SECTION 00 91 13.4 – ADDENDUM 4

- A. Project Name: Lincoln Quad Demolition and Site Restoration.
- B. Owner: Indiana State University.
- C. Owner Project Number: B0027341.
- D. Architect: arcDESIGN, PC.
- E. Architect Project Number: 19189.
- F. Date of Addendum: Friday, October 16, 2020

Exposed Duct Bank

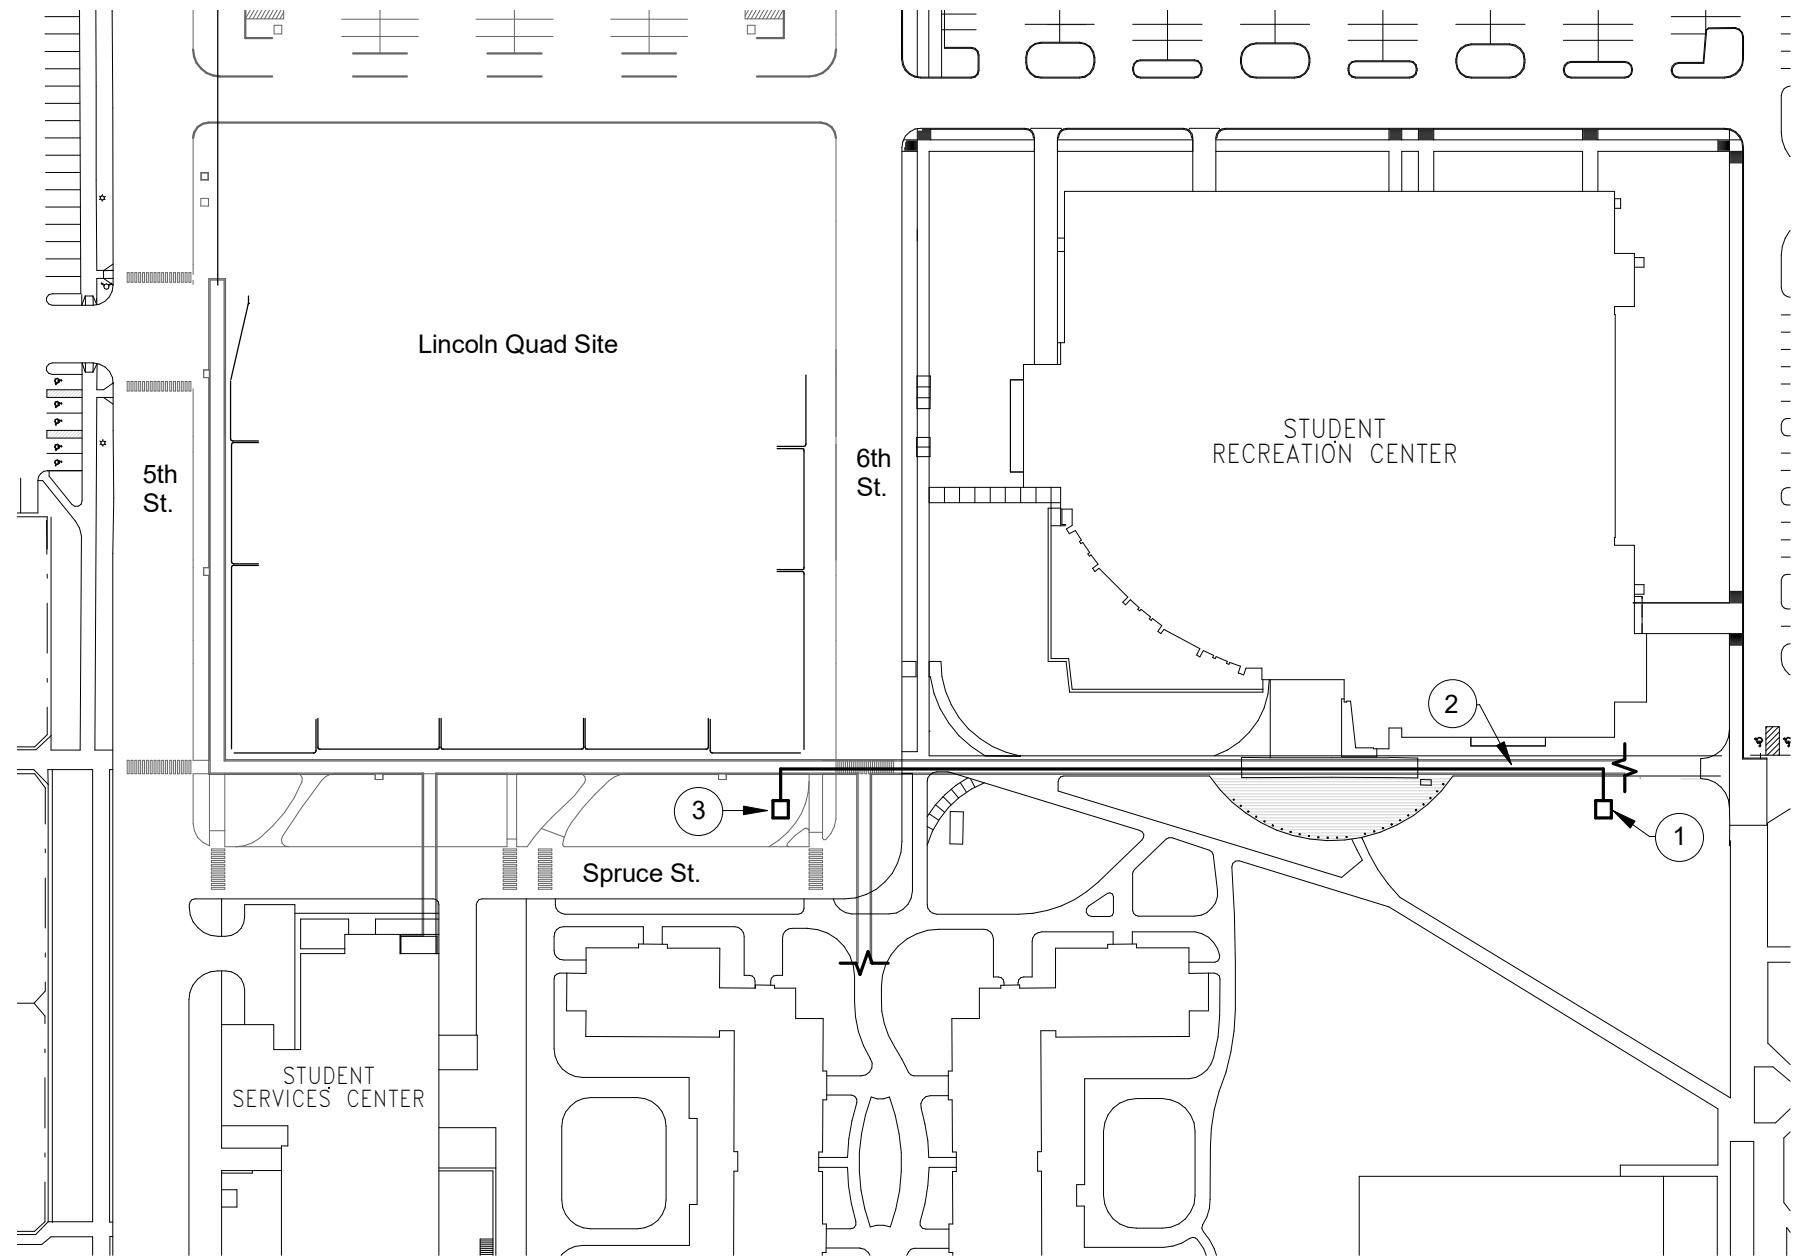
- A. Question: Please provide additional information on the size of the electrical duct bank.
1. Answer: It is believed that the existing transite ductbank consists of a 2" transite electric duct with 1#4 15KV shielded conductor with outer concentric neutral, encased in concrete envelope and buried approximately 30" minimum below grade. The duct was changed to rigid steel encased in concrete when passing under the building, driveways, etc. For bidding purposes (to calculate landfill costs), assume the concrete encased duct bank measurements to be 24" wide by 12" deep. Exact dimensions to be determined in field and costs adjusted accordingly. See attached picture for a section that was recently exposed by the Owner for exploration purposes.
